STAFF REPORT AND RECOMMENDATION TO THE DESIGN COMMISSION - Denial

CASE FILE: LU 15-251943 DZ
PC # 15-112617
Grant Park Village Phase II
REVIEW BY: Design Commission
WHEN: February 4, 2016
WHERE: 1900 SW Fourth Ave., Room 2500A
Portland, OR 97201

5-story market rate housing (163 units) project with one level of sub-grade parking (97 spaces) and at-grade parking (10 spaces and loading) including frontage improvements (half-street on NE 32nd Ave) and new storm water treatment facilities. The project proposes a Floor Area Ratio of 2.4:1 (4:1 allowed) and a height of 55'-8" (100' allowed).

EXTERIOR ELEVATIONS

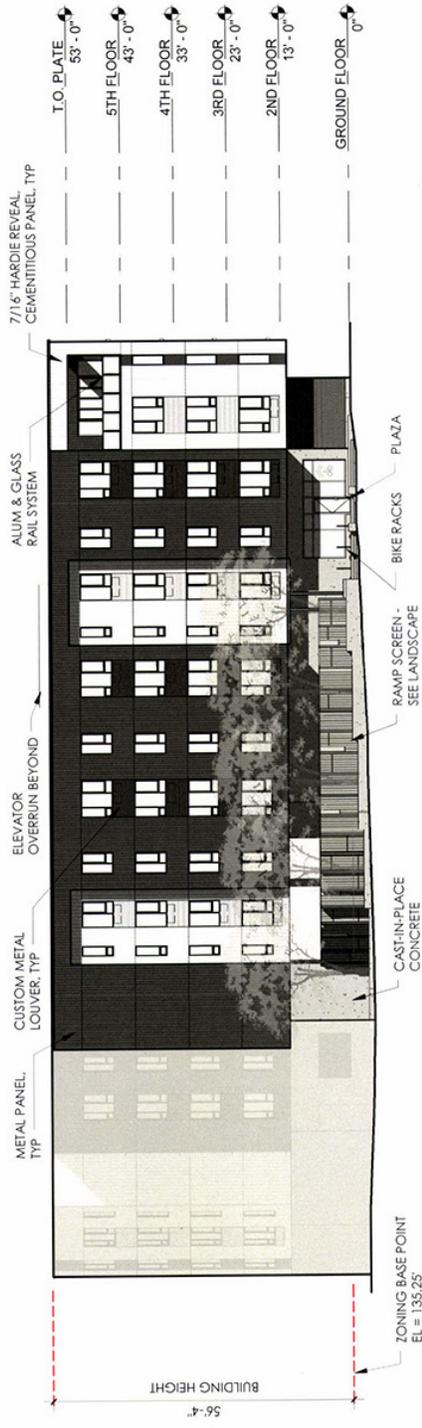
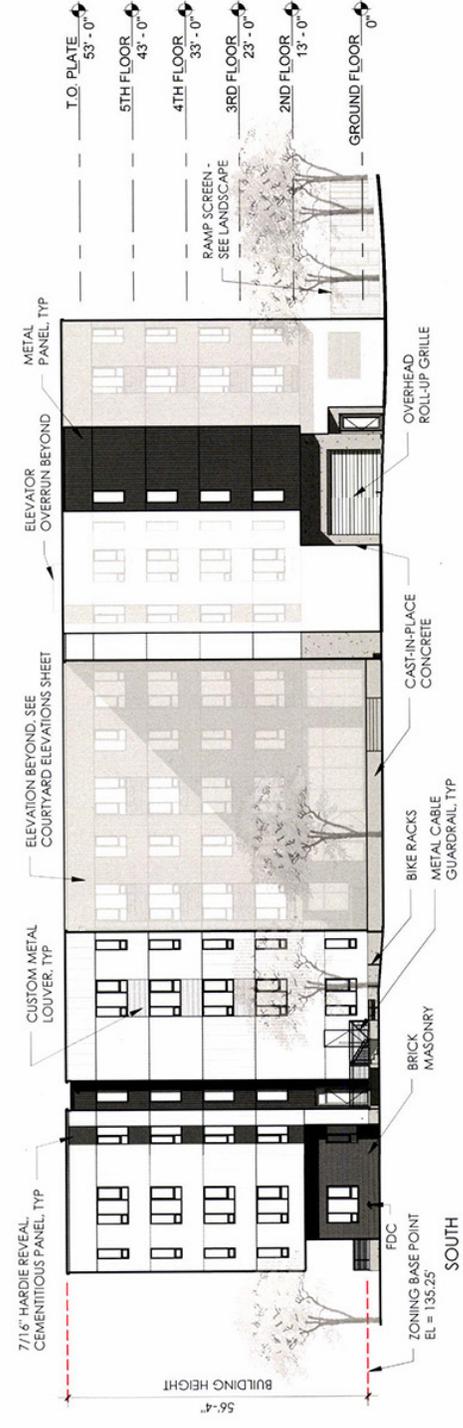
With additional measures – *more fully resolved detailing of cladding assemblies, upper-floor amenity space, balconies, buffering of ground-floor residential and better concealed ground floor parking* – this guideline could be met. However, as proposed, the project lacks interest and cohesion, especially on the eastern elevation abutting public open space with direct views from vicinity ROW (NE 33rd Ave).

- Excessive use of metal panel cladding without sufficient design detail to ensure lack of oil canning and a quality composition;
- Lack of detailing associated with unit air conditioning ports and PTACs;
- Lack of upper-level amenity space and balconies;
- Insufficient vertical and/or horizontal setback and buffering of ground floor residential units; and,
- The exposed parking deck at the east elevation and abutting the central courtyard.

COURTYARD ELEVATIONS

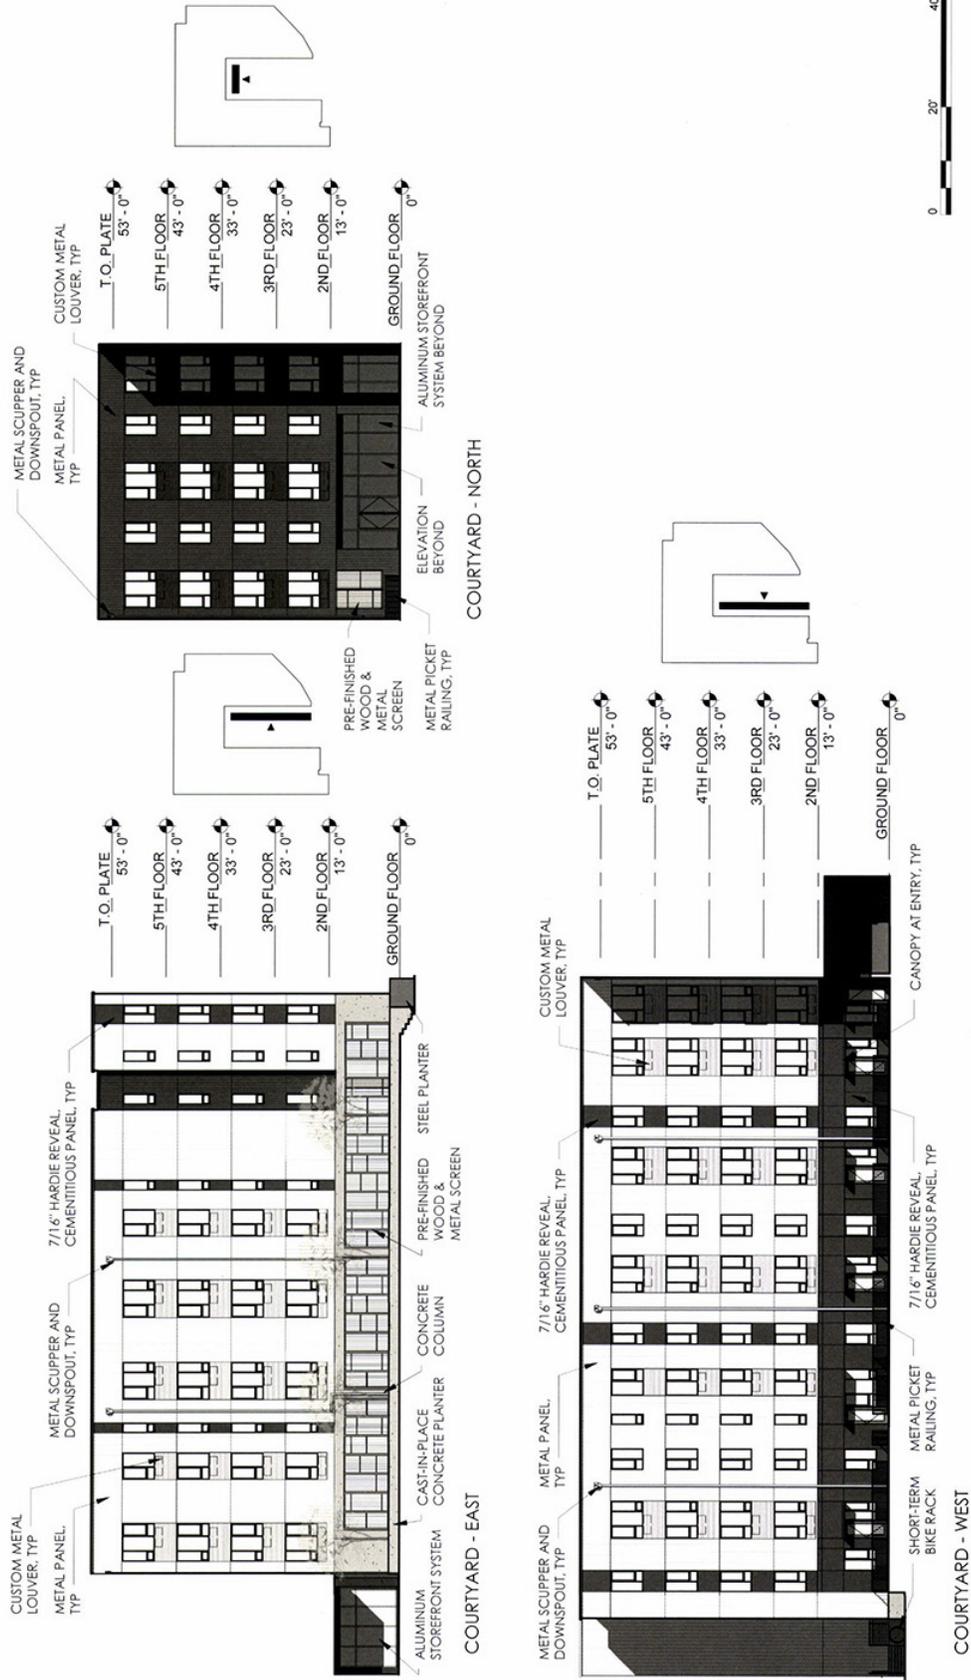
Finding for D1: The development provides two outdoor areas that are connected to interior and perimeter circulation systems – the central plaza oriented southward to the Sullivan Gulch Access Easement and the small plaza oriented northeasterly toward Grant Park Village Phase I. Though these features contain accessible walkways, landscaping, expressed stormwater management, and gathering places, their place-making value is significantly compromised by the adjacency of floor area (exposed parking and auto circulation) fundamentally incompatible with the notion of pleasant and safe public space.

Findings for D4: While a majority of the on-site parking is well-concealed below grade, a significant amount of naturally ventilated auto parking and inactive floor area is located at-grade adjacent to proposed public amenities – central courtyard, small plaza at northeast corner and sidewalk abutting the east elevation. The location of this parking related program oriented to adjacent public space intended to be shared by all residents of the “Village” is not complimentary to the public space value of these amenities.
